**Planning Permit WYP9630/16 – 37-43 Cherry Street, Werribee
Section 72 Amendment and Submission of Plans for Endorsement**

1 Introduction

2 Proposed Amendments

Figure 1. Elevation Comparison

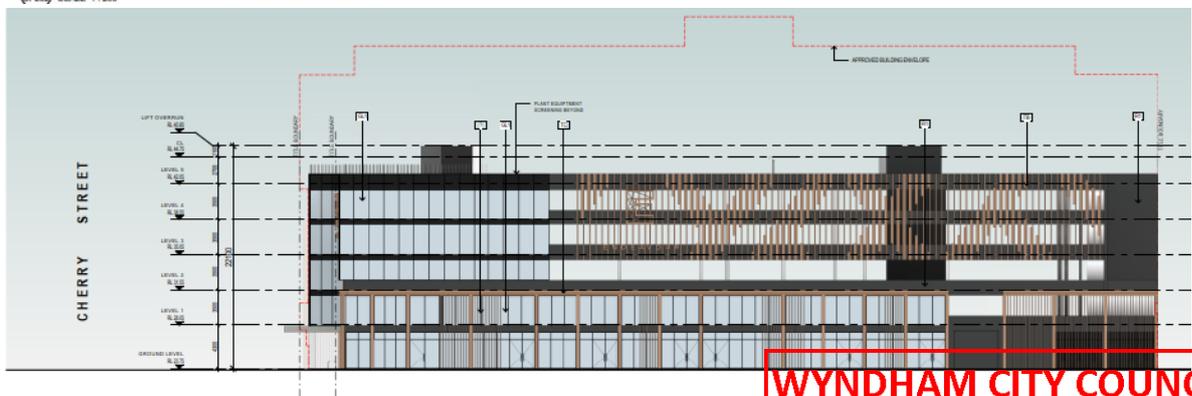
- Reducing the total building height to 22.1m in accordance with the preferred building height of 8m to 25.5m nominated in the *Werribee City Structure Plan (June 2013)*, by removing Levels 6-9 (Figure 1).
- Increasing the ground level activation to all Kelly Street, Jellicoe Street and Cherry Street by introducing ground-level commercial tenancies fronting Kelly Street and Jellicoe Street (Figure 2).

Figure 3. Level 1 Comparison

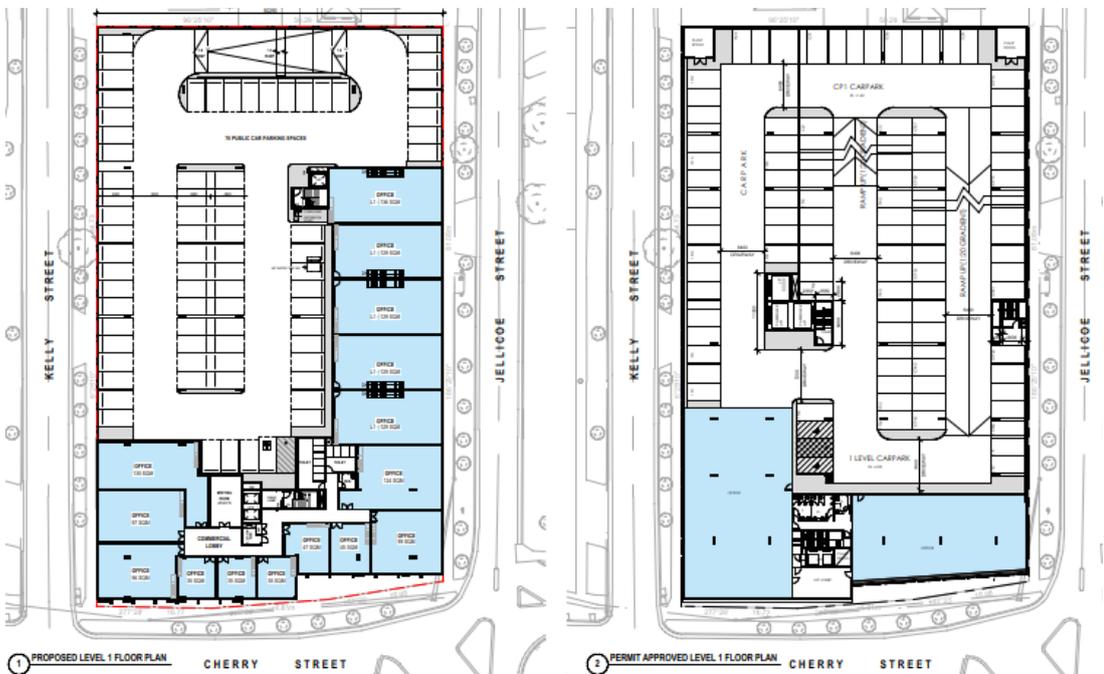
- Increasing the level of screening provided to car parking areas by providing office tenancies along the Jellicoe Street frontage on Level 1 and office tenancies fronting Cherry Street on Levels 2-4 (Figure 3).
- Utilising high-quality materials including clear glazing and timber blades to provide articulation and visual interest across the façade.
- Removing sections of concrete wall façade along the Jellicoe Street and Kelly Street frontage.
- Providing a patterned treatment to upper levels of the northern façade to provide visual interest and clear visual break with lower levels.
- Providing vertical timber elements within the east and west-facing facades to prevent undue overlooking into residential properties and provide articulation and visual interest.

Figure 4. Cherry Street Elevation Comparison

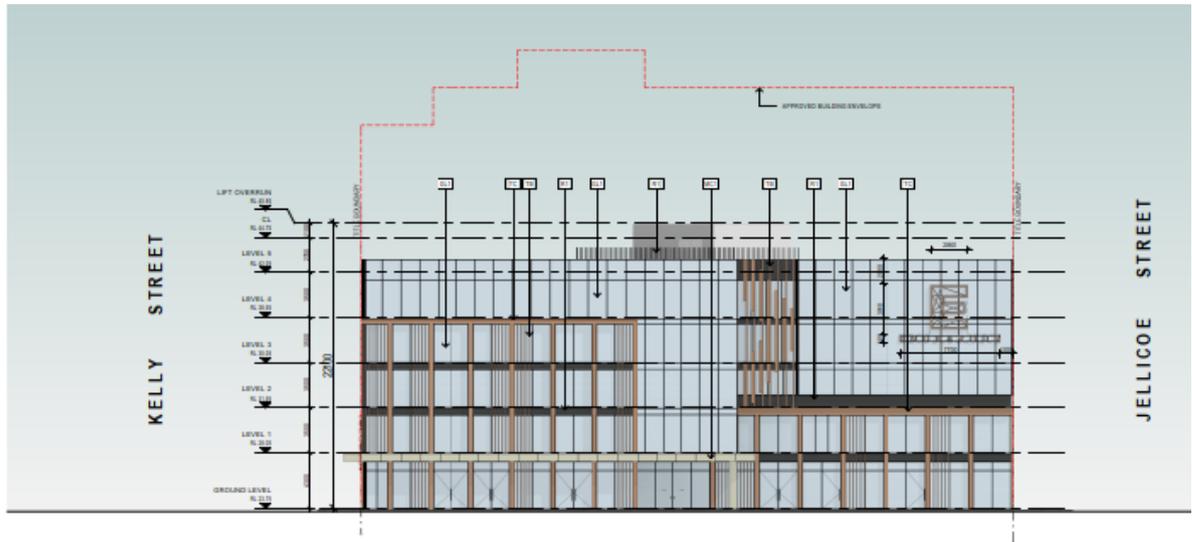
A Permit is required under Clause 52.05 (Signs) of the Wyndham Planning Scheme to display the proposed Internally-illuminated, High wall, Panel signs on the Cherry Street and Jellicoe Street frontages.

The Permit preamble (as currently approved) does not provide approval for the display of advertising signs. However, the existing endorsed plans identify a 24m² 'proposed sign' on Level 5 of the Cherry Street Elevation (Figure 4).
